REQUEST FOR RULING

To the Joint review Panel re Ontario Power Generation Application for a Deep Geologic Repository for Low and Intermediate Waste (DGR):

OPG's Deep Geologic Repository for Low and Intermediate Level Radioactive Wastes Environmental Impact Statement March 2011

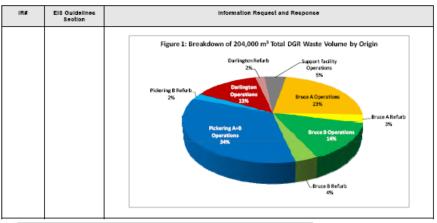
Provide a specific break down of waste volumes per reactor and per activity, in the form of a pie chart. Identify whether any decommissioning waste is in the current proposed project description.

On page 3-2, in section 3.1 'Purpose of the Project' it states if the fleet of 20 reactors each operate to the end of life (a nominal 50 years), which assumes refurbishment of each of the generating stations, approximately 200.000 m₃ (emplaced volume) of operational and refurbishment L&ILW would be produced".

On page 3-4 of the EIS, it states "...as a result of the refurbishment and improvements activities it is expected the life of each reactor unit will be extended for up to 25 to 30 years." "About 21,000 m3 of radioactive waste will be generated from the planned refurbishment activities".

It is not evident if the amount of 21,000 m3 is the waste generated from each of the 16 reactors (20 minus 4 at Pickering B) or a combined amount for all ongoing and possibly planned refurbishments. Also, on the page 3-4, OPG states that, "in the future, an additional approximately 135,000 m3 of L&ILW is expected to be produced during the decommissioning of the [20] reactors and the associated nuclear waste storage facilities." The next sentence reads: "The currently proposed DGR Project does not include management of decommissioning waste".

As documented in the DGR reference inventory report (OPG 2010, Tables 2.1 and 3.1), the amount of waste to be placed in the DGR within the scope of the application is approximately 182,300 m₃ of "operational" low and intermediate level waste plus 21,700 m₃ of "refurbishment" low and intermediate level waste, for a total of 204,000 m₃. This represents the total of all as-packaged waste from OPG owned or operated reactors for emplacement in the DGR, and uses the radiologically-conservative assumption that all reactors except for Pickering A are refurbished for continued operation. (In this context, radiologically-conservative" means maximizing the radionuclide inventory of the waste for postclosure safety assessment purposes.)

The breakdown of the 204,000 m₃ by station and activity is given in Figure 1 below. The "operational" waste includes both the pre- and post-refurbishment periods. The OPG owned or operated support facilities include the waste management facilities at the Pickering, Darlington, and Bruce sites; and the Darlington Tritium Removal Facility, health physics labs, the Central Maintenance and Laundry Facility at the Bruce nuclear site, and other similar facilities required to directly support the operation of the nuclear generating stations.

In addition to this, approximately 135,000 m₃ of decommissioning low and intermediate level waste is expected to be generated in the future. As reported previously in OPG's response to Information Request EIS-04-102 (OPG 2012), this is not included in the current DGR project scope inventory. However, it is identified in the Cumulative Effects Assessment in the Environmental Impact Statement (OPG 2011, Section 10.4.1) as a "reasonably foreseeable" future project. As shown below in Figure 2, the 135,000 m₃ of decommissioning waste can be allocated as approximately 17% Bruce A, 18% Bruce B, 33% Pickering A + B, 29% Darlington, and the remaining 3% for the miscellaneous support facilities.
